NHTSA Recall # 20V-433
Transport Canada # 2020-357
Tiffin Recall # TIF-113

VIP Wiper Module Power Source Recall

Tiffin Recall TIF-113, VIP Wiper Module Power Source Recall

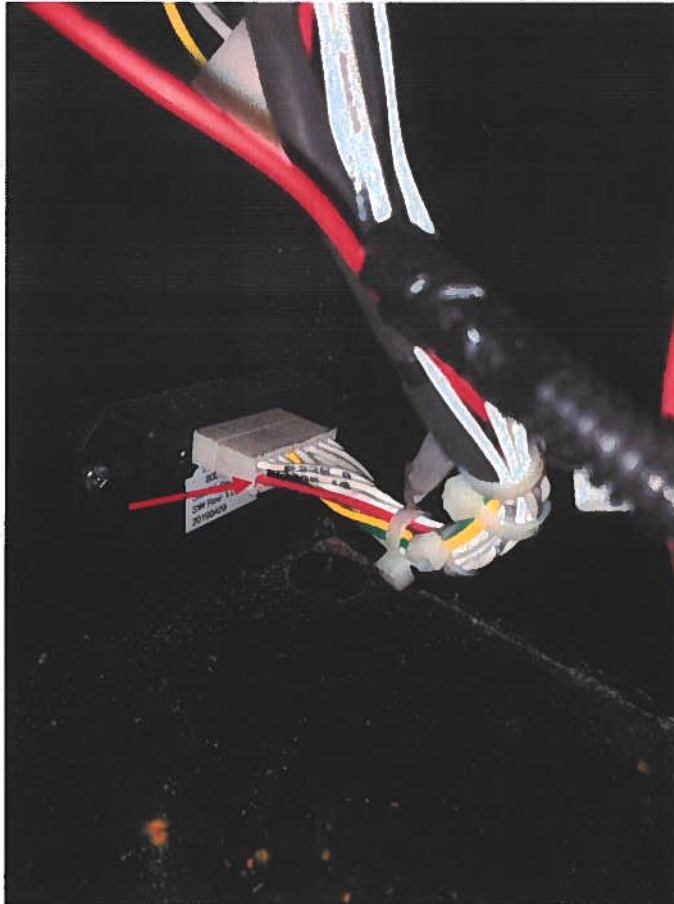
Driver's may be warned that the windshield wipers will not work if the cruise control on the motorhome is not working. The wiring for the cruise control is linked to the wiring of the windshield wipers. If you have noticed issues with the cruise control not operating, this may be a warning sign that your windshield wipers are also not working. If that is the case, the following steps may be followed to *temporarily* reset the wipers until you are able to schedule an appointment to have the recall work completed. 1. Open the first compartment on the driver's side of the motorhome, this is the electrical compartment. 2. Unplug the VIP power module plug, then

plug it back up. We have included the following pictures to show the location on the VIP power module plug. The plug is circled in RED.

(figure 1)

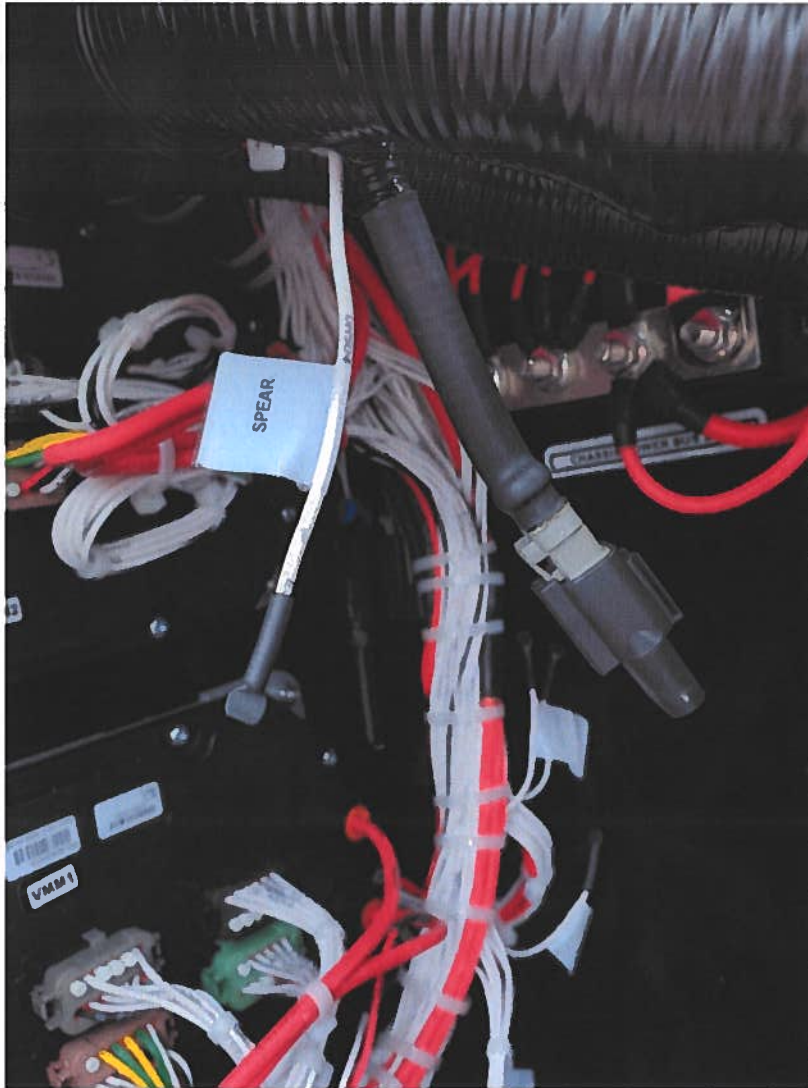
This document will go through a step by step process to fix the VIP module power source. The VIP module is a small, black module with a single plug. The module is located in the bottom left of the front electrical box. The module and plug being modified are pictured below (figure 1).

The sockets should be numbered on the plug itself. Also shown in figure 1 with a red arrow. Socket 1 will be the only wiring change being made.

Confirm 12-volt power source on VIP module socket 1

- 1) With the ignition key in the **OFF** position, use a volt meter or test light to check for 12 volts at socket 1 of the VIP module connector (see figure 1). If there is 12 volts present with the ignition key OFF proceed to step 3.
- 2) If you do not have 12 volts at socket 1 with the key off turn the ignition key to the on position and again check for 12 volts at socket 1. If 12 volts is present **only** when the ignition is on no further work is required.

(figure 2)

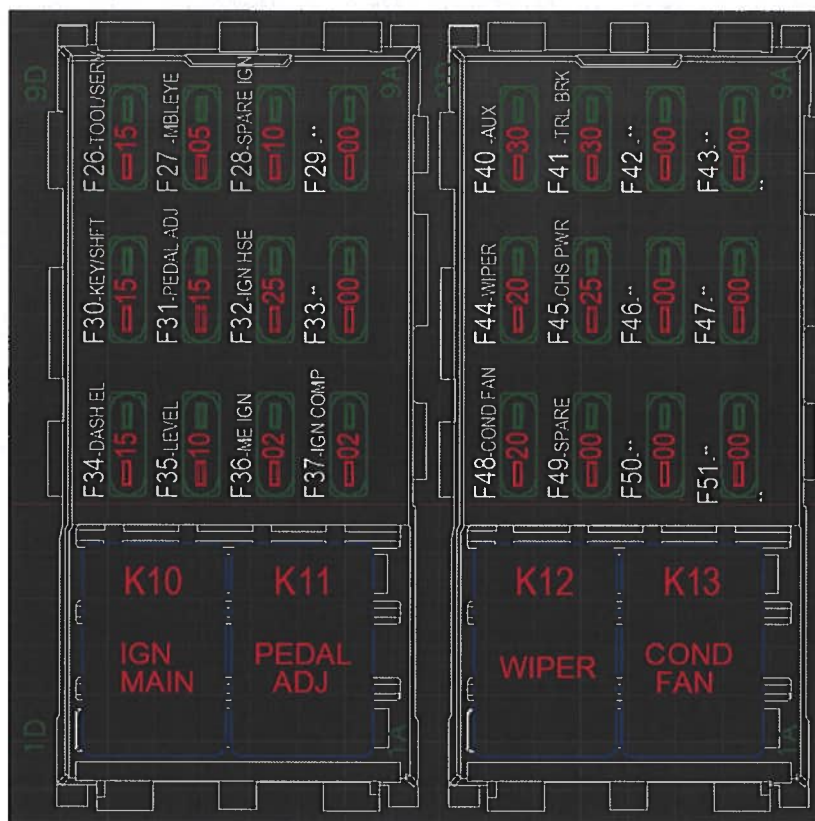
- 3) Locate the wire in socket 1 (wire color may vary). Cut this wire approximately 4 inches back from the connector leaving a "pigtail" coming from socket 1. Use heat shrink material to safely protect any exposed conductor on the harness end of the wire. Tie this wire up and out of the way so that it cannot become shorted.
- 4) Locate the spare ignition wire in the electrical box (see figure 2). This wire will be labeled "SPEAR" with a flag label. This wire will be located in the same breakout as the single diode. The wire be marked as DH904 on the insulation of the wiring.

- 5) Splice an additional length of wire between DH904 (spear) and the pigtail left in socket 1 of the plug. Be sure to solder and heat shrink both splices. Reconnect the plug to the VIP module.

- 6) Locate the fuse blocks mounted in the electrical box (see figure 3). Locate fuse F28 pictured below and labeled on the door of the electrical box. This will be a 10-amp fuse. Replace it with a 2-amp fuse.

- 7) Locate the fuse labeled “F44 wiper” (see figure 3). This should be a 30-amp fuse. If the fuse in F44 is a 20-amp fuse remove the 20 amp and replace it with a 30 amp.

NOTE: Due to design changes, some 2020 models will not have the wiper fuse located at “F44”. These units do not need any changes to the wiper fuse. If you have a 2020 Model Year coach Step 7 may possibly be disregarded.
